<b>IODP</b>		
<b>RIS Schematic</b>		
Dean Ferrell	Rev. 3.8	Rev. IODP ET
	09/04/2023

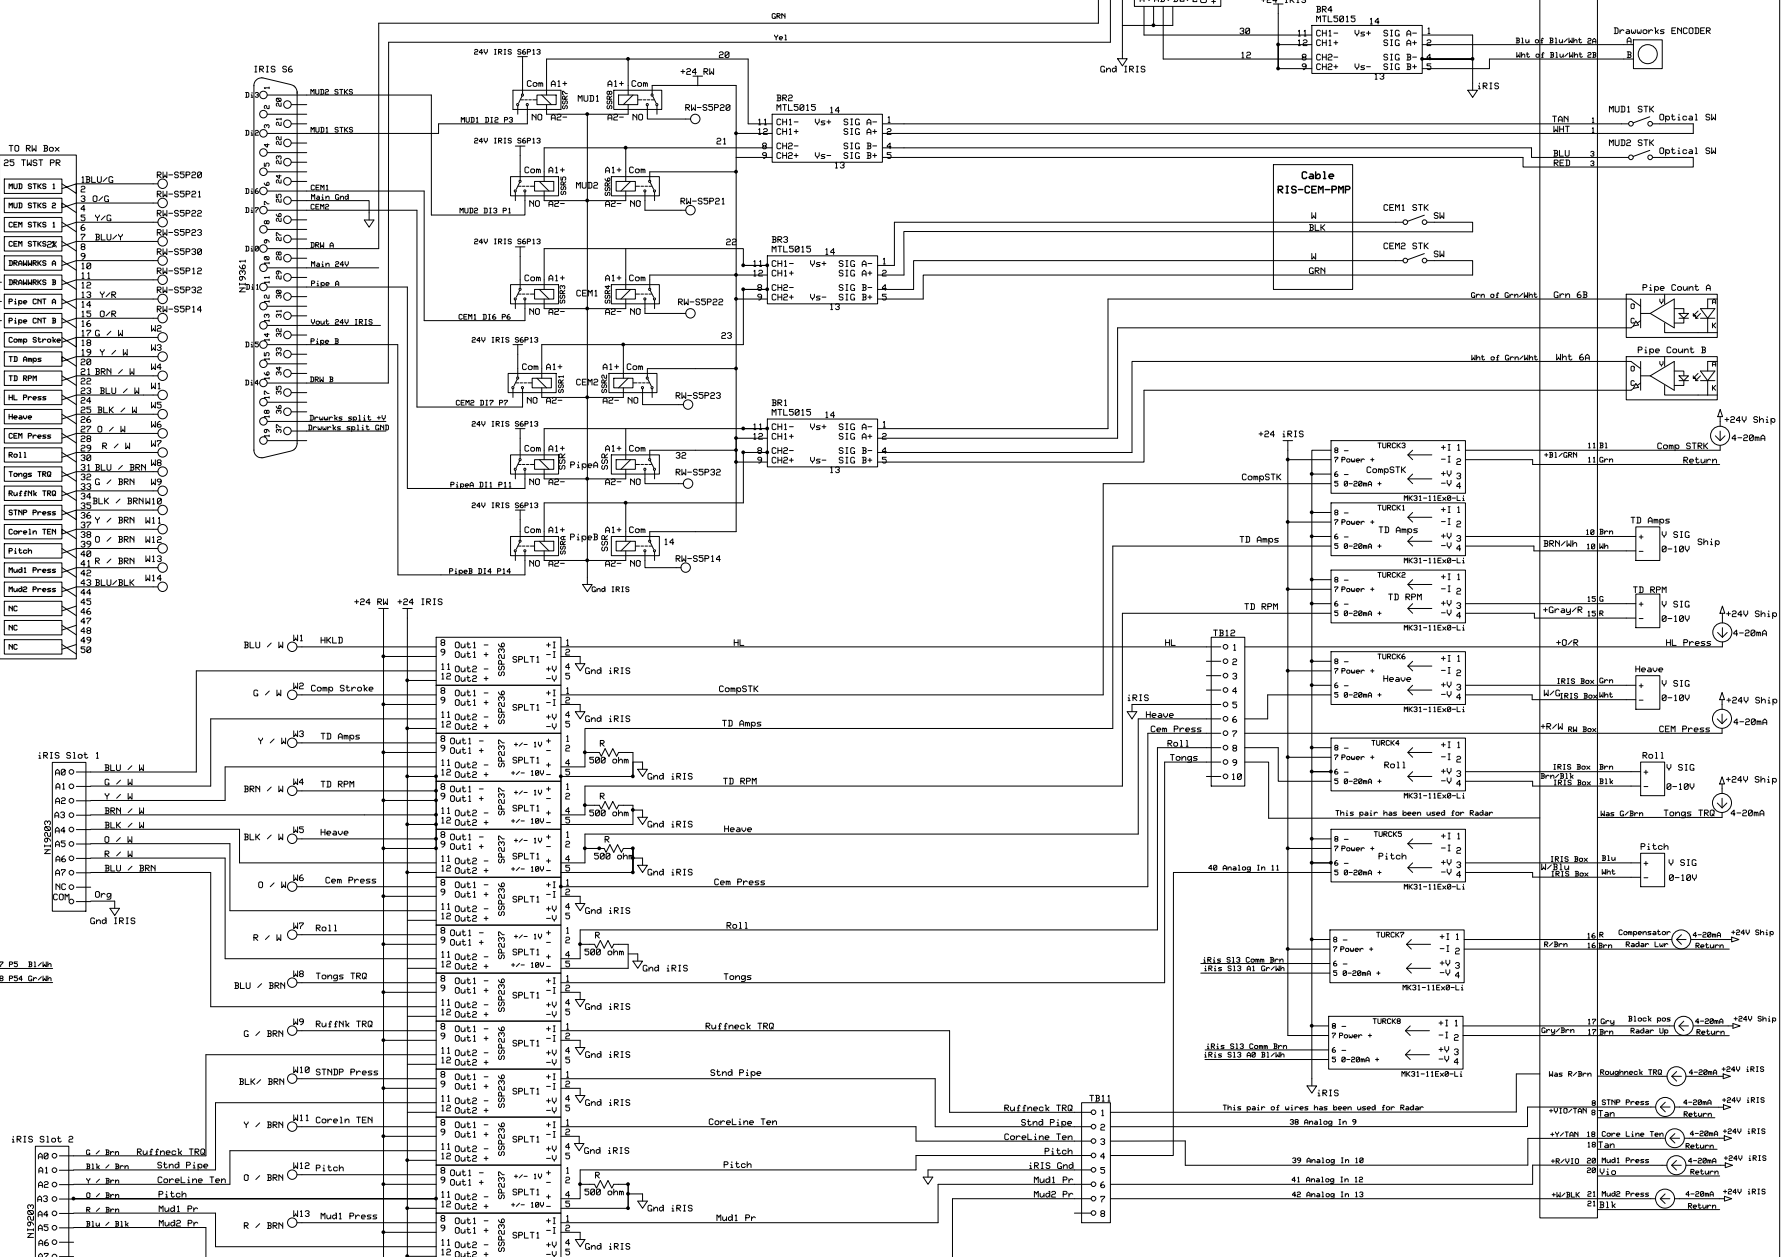
1. Swapped TD amps W/Brun to Brn/W. Sees the Pos & Neg voltage are wrong from SIEM side
2. Re-numbered the TURCKs from 1-4
